Subject: Dresden Nuclear Power Station Units 2 and 3
Quad Cities Nuclear Power Station Units 1 and 2
Response to Request for Additional Information (RAI)
NRC Docket Nos. 50-237/249 and 50-254/265

RESPONSE TO REQUEST FOR ADDITIONAL INFORMATION
CONCERNING CORE SHROUD CRACKING

**RESPONSE TO NRC REQUEST FOR ADDITIONAL INFORMATION
CONCERNING CORE SHROUD CRACKING AT
DRESDEN, UNITS 2 AND 3, AND QUAD CITIES, UNITS 1 AND 2**

H5 BOUNDING FLAW DETERMINATION

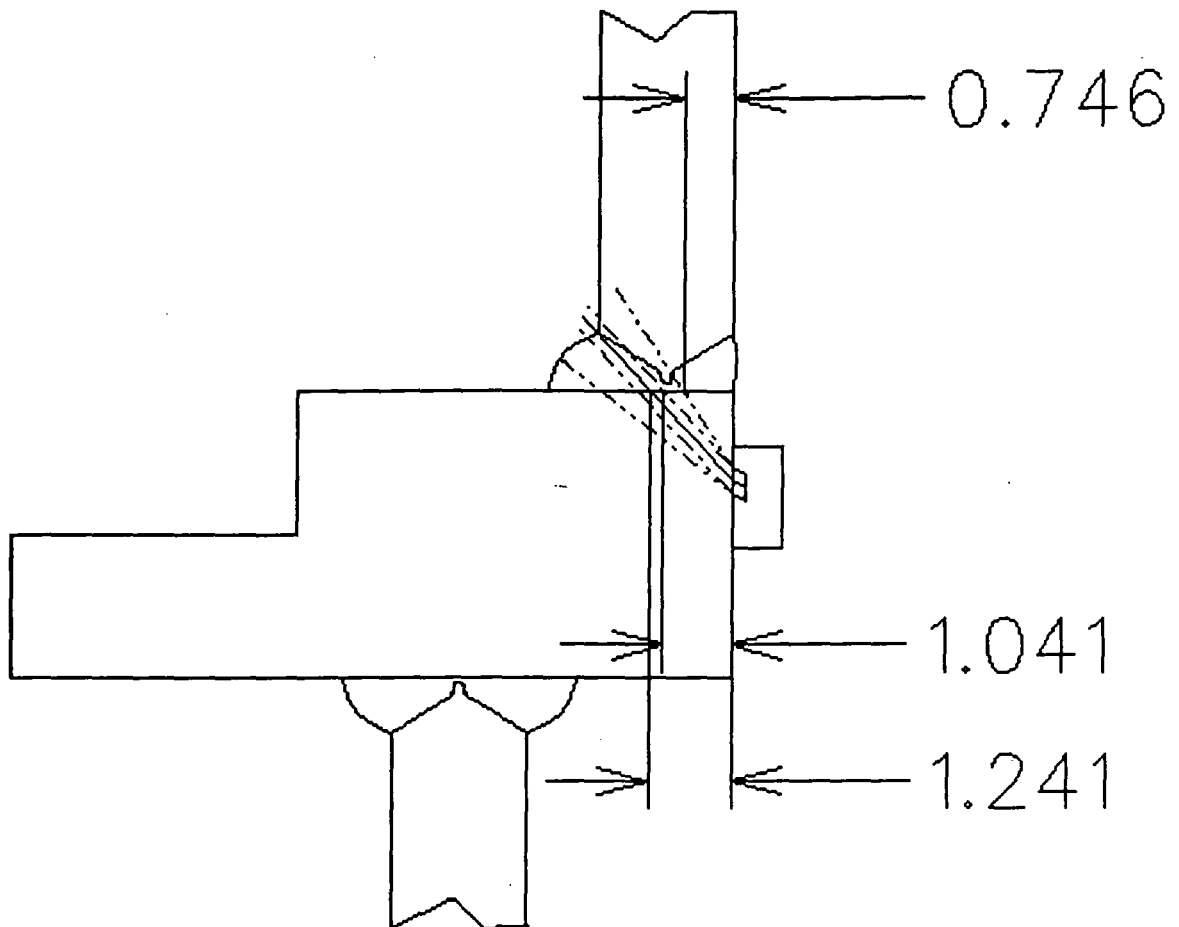
However, due to the design of the H5 weld at Dresden and Quad Cities stations, the UT examination results can be used to demonstrate that the flaw can not be any greater than 1.24" in depth. The H5 weld contains a 1.0" reinforcing fillet on the ID of the weld. A signal from the toe of this reinforcing fillet at the shroud cylinder was observed with the 4th transducer throughout the entire H5 examination. As can be seen from Figure 1, a flaw that started at the sound beam entry surface and intersected the sound beam at its central axis would be 1.24" in depth. A flaw any deeper than this would prevent the sound beam from reaching the toe of the reinforcing fillet and the signal from this reflector would be lost. Based on the above, the bounding depth of the H5 cracking at both Dresden Unit 3 and Quad Cities Unit 1 is 1.24".

Based on the results of automated and manual UT exams of the H5 welds and on the results of boat samples taken from the H5 welds of both units, the probability of detection of flaws deeper than 1.24" on the core plate support ring side of the H5 weld is very high, and no flaws deeper than 1.24" were detected in either unit. For this reason, the bounding maximum flaw depth used for both units for the purpose of structural margin assessment is 1.24". See the response to Question (2) for details.

FIGURE 2
LOCATION OF WELDS

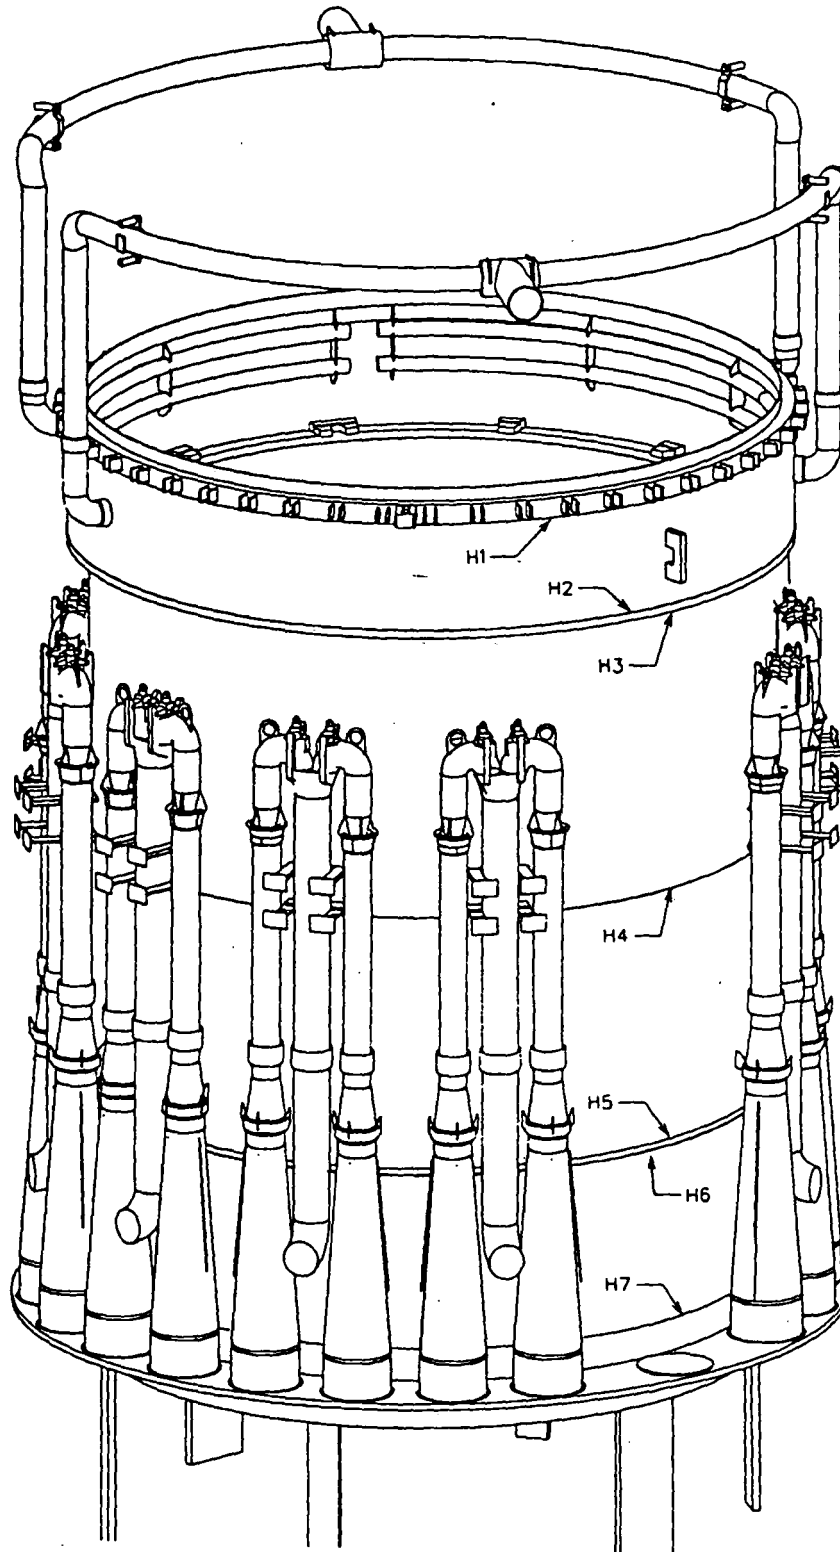
The original scope of the core shroud inspections at Dresden 3 and Quad Cities 1 consisted of a visual examination of the circumferential shroud welds H1 through H7 (as shown on Figure 2) from the outside diameter and, where accessible, from the inside diameter. The primary objective of the inspection was to identify sufficiently distributed unflawed material at each weld location to positively demonstrate shroud integrity under all design basis events for at least one operating cycle.
